February 12, 1934.

Charles T. Biele & Son
33 Bethune Street
New York City.

Enclosed please find dimensions for polychromed wooden statue for which we are considering ordering a case to be made by your firm. I am also enclosing a photograph of the statue and a small drawing indicating the dimensions of the case we have in mind.

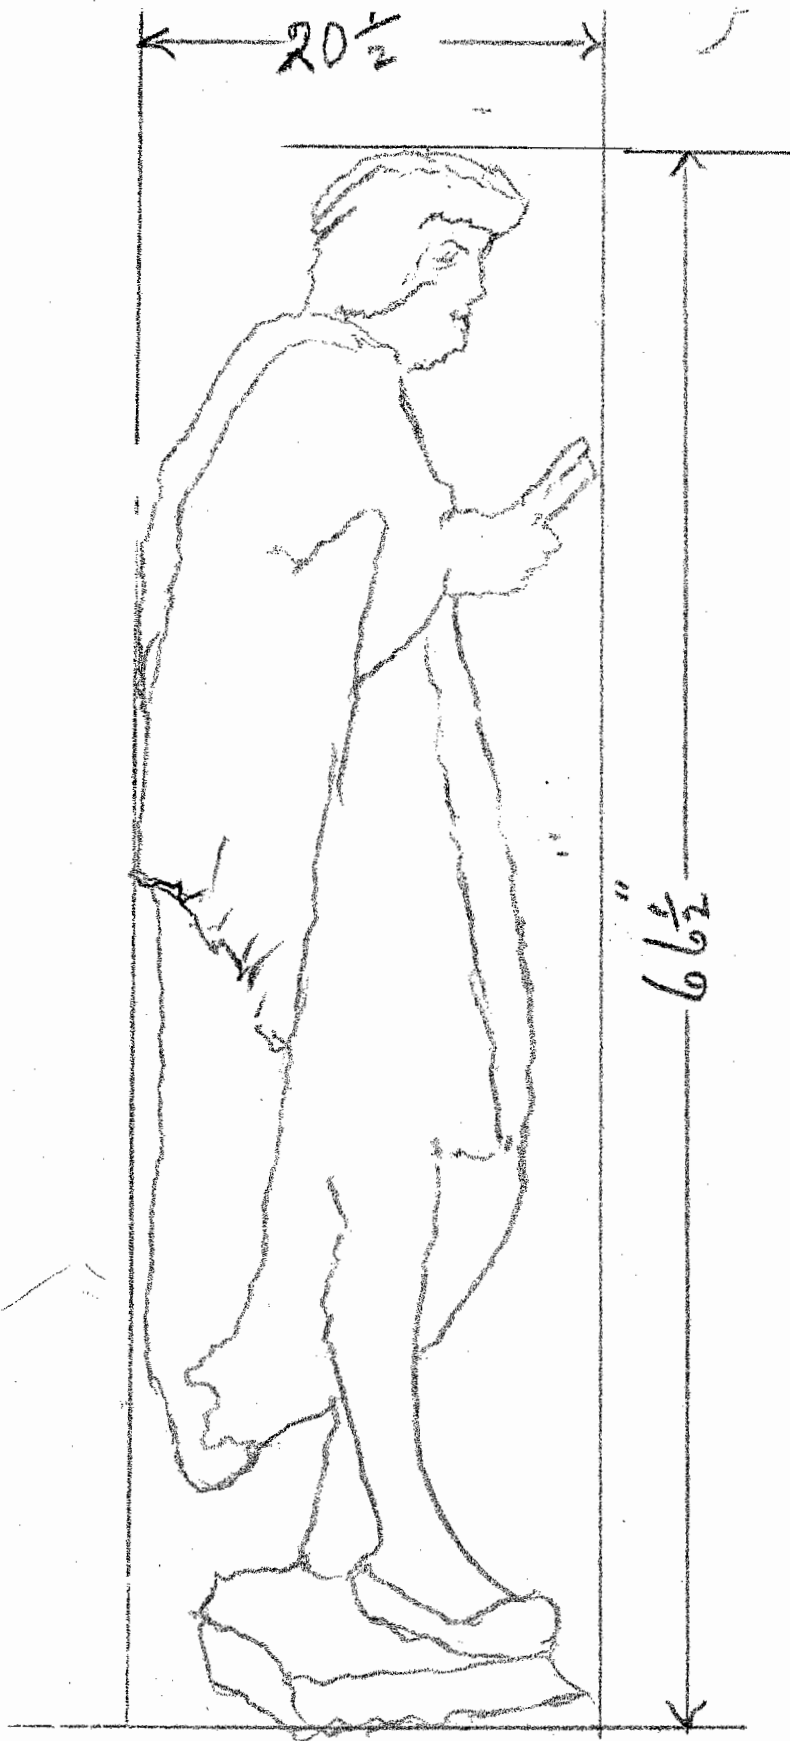
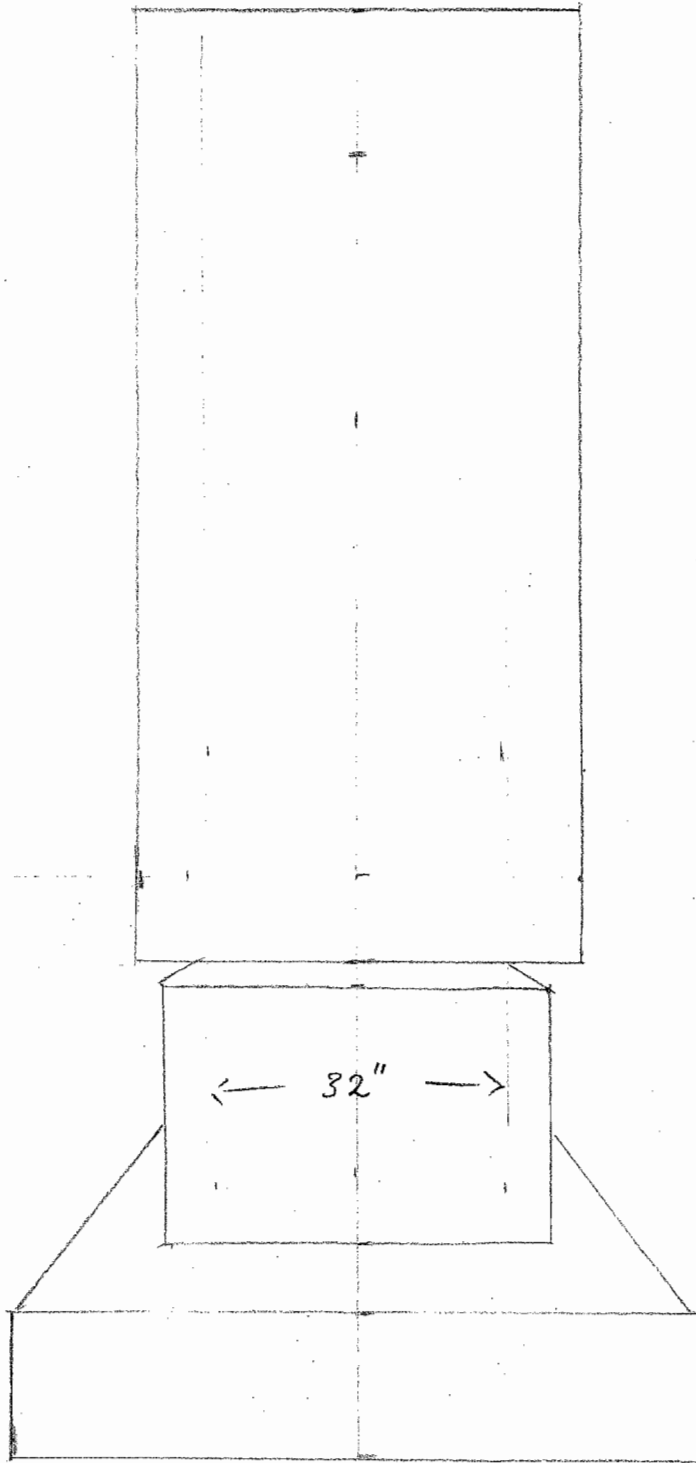
Since discussing the building of the case this morning with my superintendent, Mr. Leeder, I conclude there are serious problems involved in building a rigid, airtight glass case without metal supports such as we had planned, and I should like you to let me know your reactions to these difficulties as outlined below.

Mr. Leeder informs me that not only Chicago but also other museums in the country have tried the rigid glass construction case in large dimensions and found them most impractical due to the fact that the cases tend to crack and break when rigidly joined as in our projected plan. As a result, such cases are now made by these museums with a felt strip at all joints to allow for the difference in the speed of contraction and expansion of the various glass plates of which the cases are composed.

In replying with an exact drawing and estimate of the cost of the proposed case, will you be so good as to let me know whether you can guarantee the kind of construction we had planned against possible cracking or breaking under normal conditions, or whether you advise felt strips being used. If the latter be the case, I am surprised you would have undertaken the kind of construction I wished without having warned me of this possible danger. I therefore take it for granted you have some answer to make to the above criticism. Also will you tell me whether, if felt is used at the joints, the case would be air and moisture proof.
